Product hierarchy no. *			Part no.	SBU	Type / Description	Customer part no.
SBU PG	PGU	Type				
02 005	016	0000001166	See list below	Power Entry Modules w/o Filter	DC11

2 Type of change

Change of material for higher GWFI/GWIT, V-Lock cord retaining feature as standard and the position of type marking.

Old product appearance	New product appearance

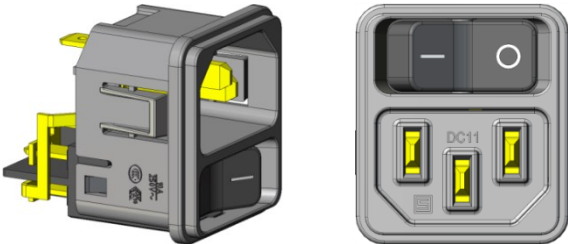
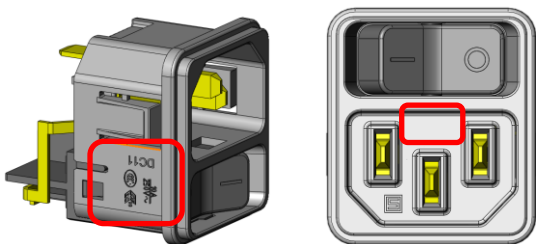
- Material change from PA6 to PA66/6 to pass the enhanced requirements of glow wire test acc. to IEC 60695-2-12 and -13
- V-Lock feature integrated as standard (not an option anymore)
- The Type-marking is new outside of the socket.

Form	Yes	Socket has notch for V-Lock cord retaining
Fit	No	There are no dimensional changes
Function	Yes	V-Lock feature is standard (not an option anymore)
Production Site	No	There is no change of the production site
Product Label	No	There is no change on the label
